<input type="checkbox"/> Sidewalk Waiver (Form V2)	
SITE PLANS	<input type="checkbox"/> Waiver to IDO (Form V2)	APPEAL
<input type="checkbox"/> DRB Site Plan (Form P2)	<input type="checkbox"/> Waiver to DPM (Form V2)	<input type="checkbox"/> Decision of DRB (Form A)
BRIEF DESCRIPTION OF REQUEST		
No change to the site plan or footprint to the three structures. Modified glazing and shade structure to south and east elevations of Building D. Garage and operable windows are incorporated into the design of the future restaurant.

AVANYU NORTH - BUILDINGS D, E & F

AVANYU NORTH - BUILDING D

Re: Request for a Minor Amendment to the approved Site Development Plan for Building Permit for the proposed new construction at 2500 12th Street NW

EXTERIOR BUILDING ELEVATIONS

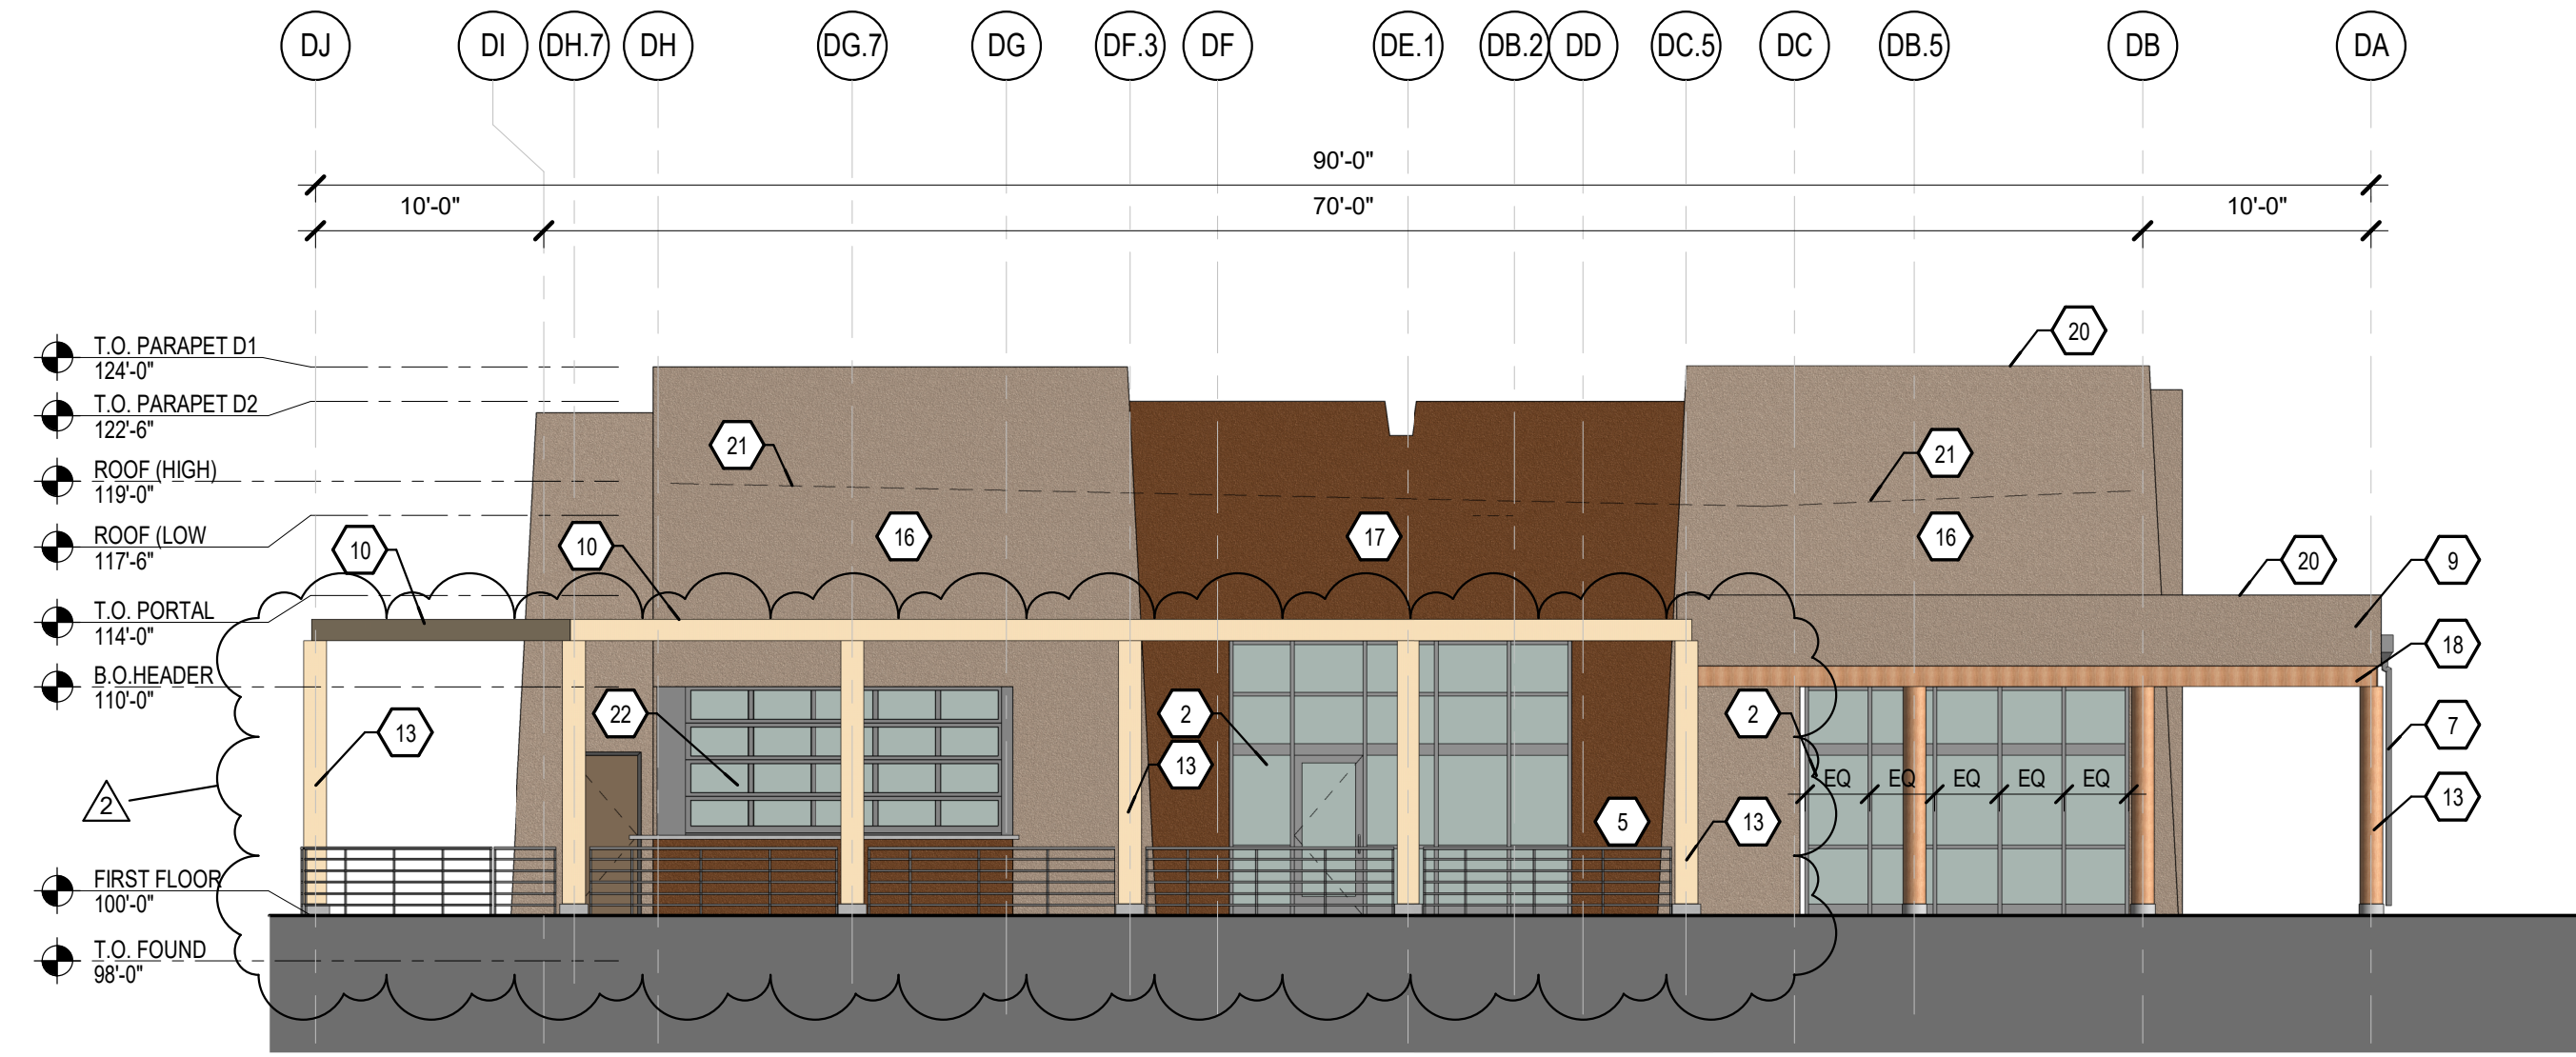
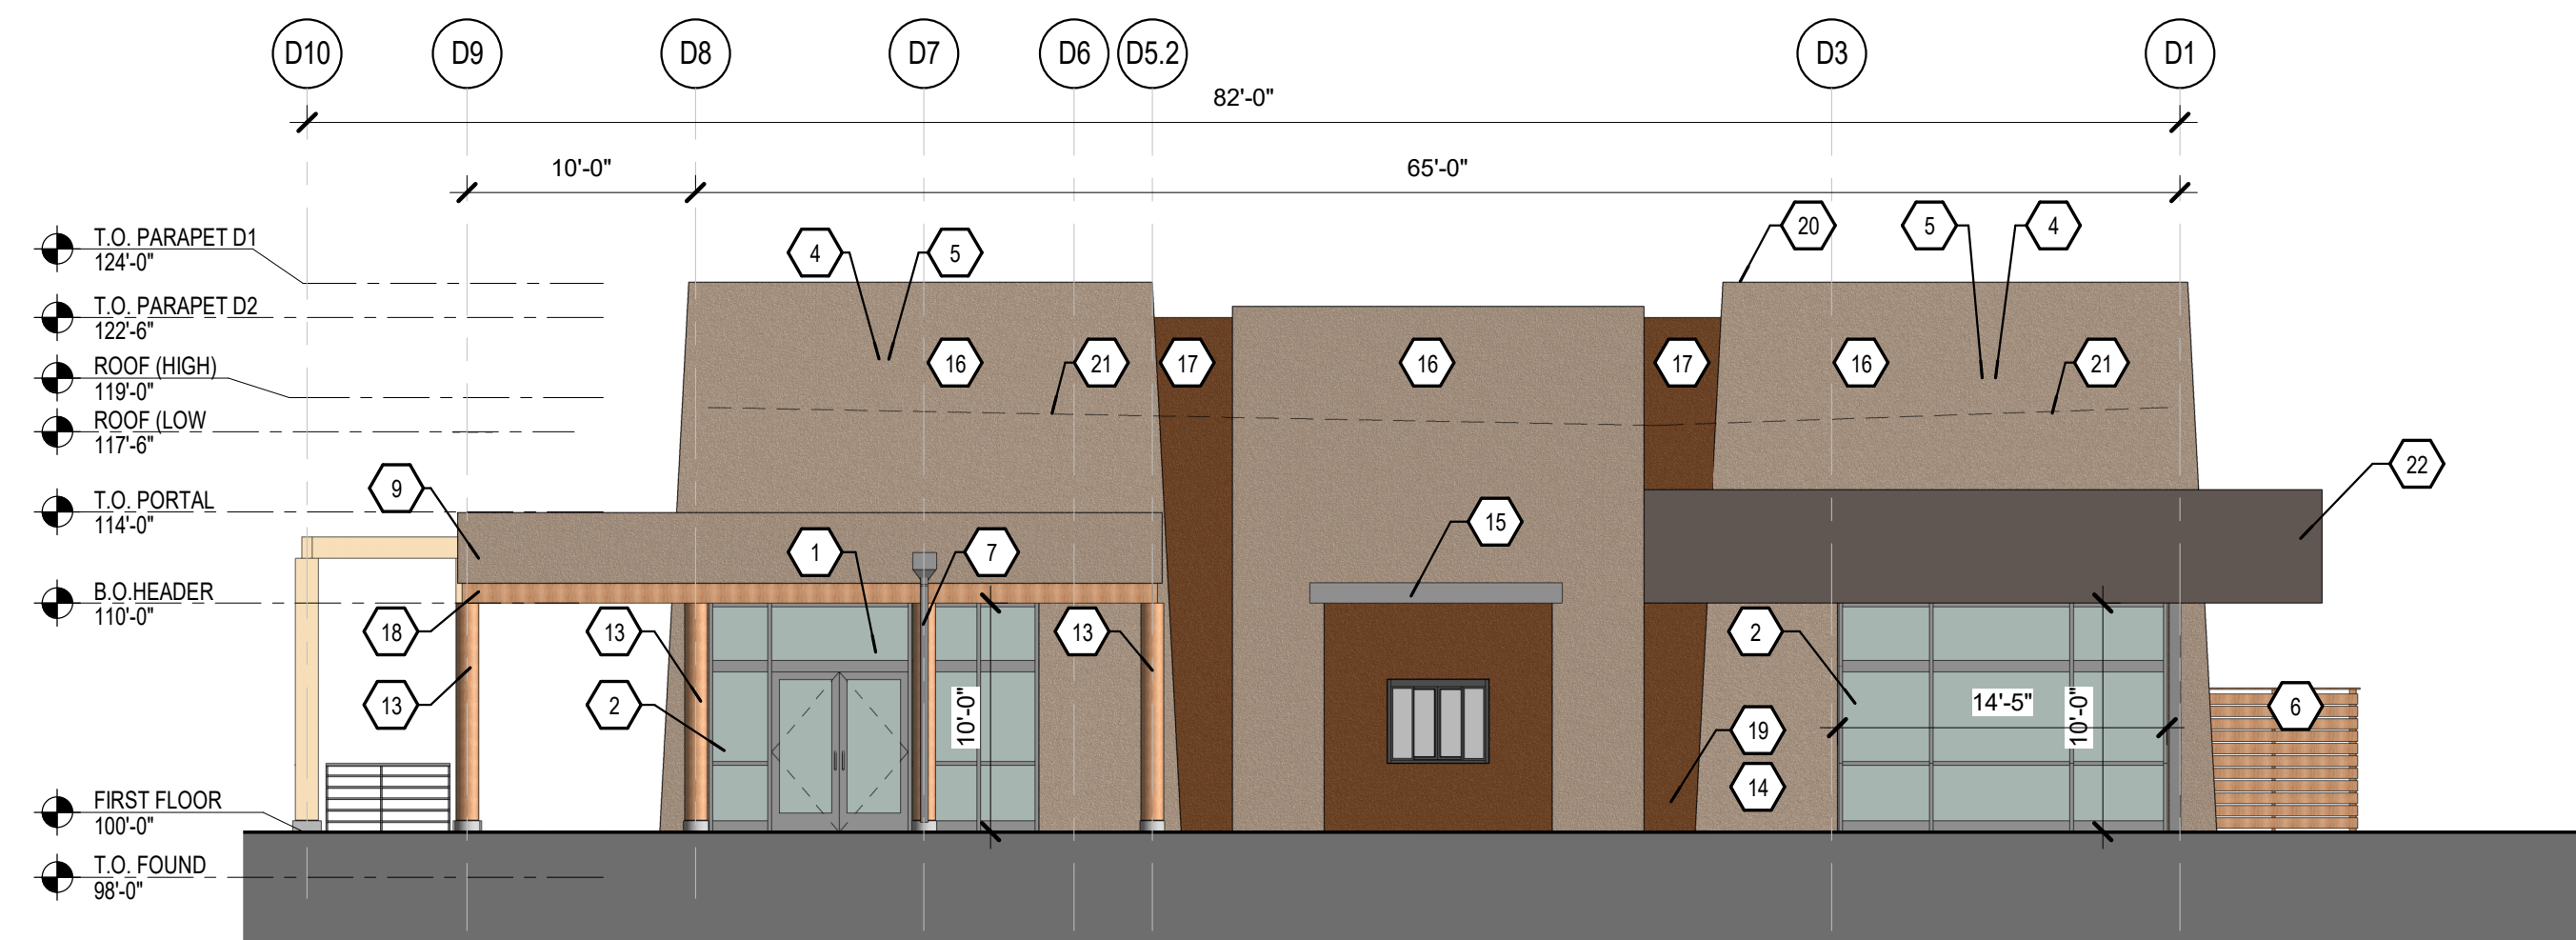
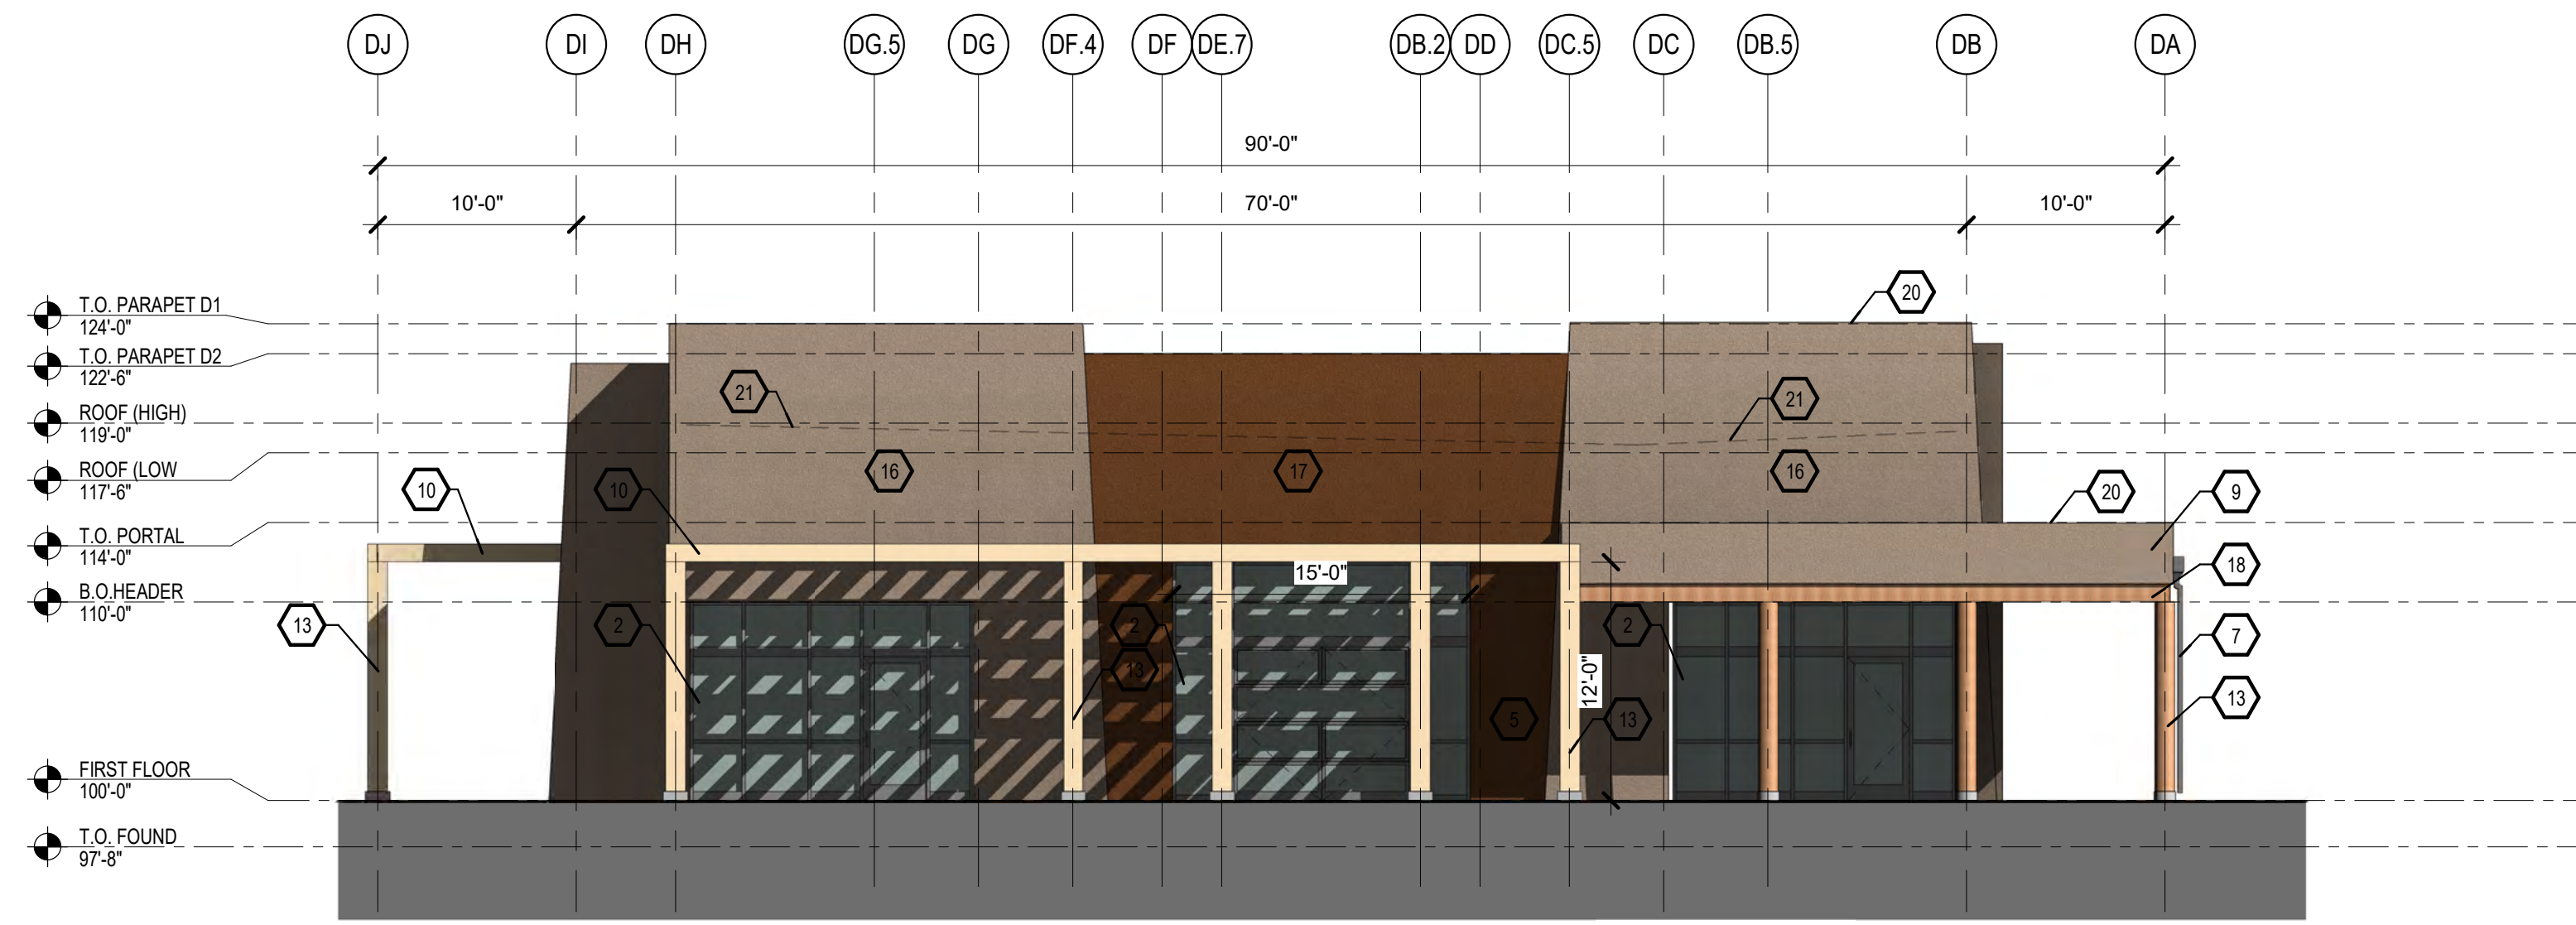
- 20. PAINTED METAL COPING.
- 21. ROOF SLOPE.
- 22. OPERABLE GLAZING / ROLL UP - GARAGE DOOR TYPE.
